Docket Item # 5
BAR CASE # 2008-0229

BAR Meeting
January 7, 2009

ISSUE: Alterations
APPLICANT: Susan Kerr, Owner
LOCATION: 610 S. Pitt Street
ZONE: RM / Residential Townhouse Zone

Figure 1: Front Elevation (Proposed Slider on First Floor, Existing Metal Window on Second Floor)

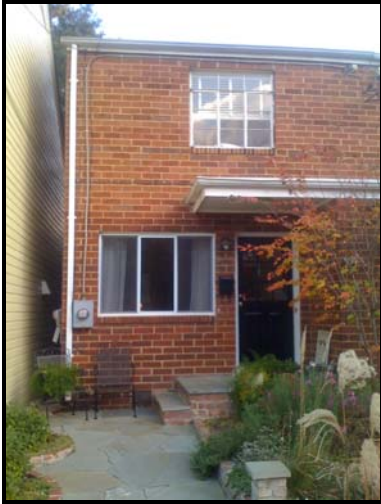
Prior to the beginning of this window replacement project, this building's front façade contained two, original, single-pane, metal, divided-light casement windows, which were installed during the construction of the townhouse (c.1950-60). The front façade currently contains one of the proposed replacement windows on the first level and an original metal casement window on the second.

The *Design Guidelines* for the Old and Historic District “discourages plastic, vinyl and metal windows”, while “single horizontal muntin metal windows and metal casement windows are only appropriate for buildings dating from the late 1940s and early 1950s’. In this case, single-pane, metal windows are no-longer fabricated in this exact form or configuration. Upon research, metal double-pane, casement windows may be special-ordered to match the original window’s divided-light pattern. As such, a determination needs to be made whether the replacement windows for this dwelling requires the replication of the divided-light metal window in a double-pane glass form, or is the proposed sliding-sash vinyl window appropriate for this application. It has been the policy of the Board that vinyl windows are inappropriate in any form in the historic district. As such it is recommended that these windows should be replaced with windows appropriate to the period and style of the building.

S-1 Substitute metal or wood casements with true-divided lights to replace vinyl sliders.

1. Rehabilitate the existing metal, single-pane windows on the front elevation of the house and, if desired, work with BAR staff to design appropriate storm windows for weather efficiency; or,
2. Remove the existing windows on the front elevation of the house and replace them with solid metal double-pane casement/fixed sash windows, fabricated to replicate the divided-light pattern and sash composition of the existing windows. These new windows may have an applied color or a natural metal finish.
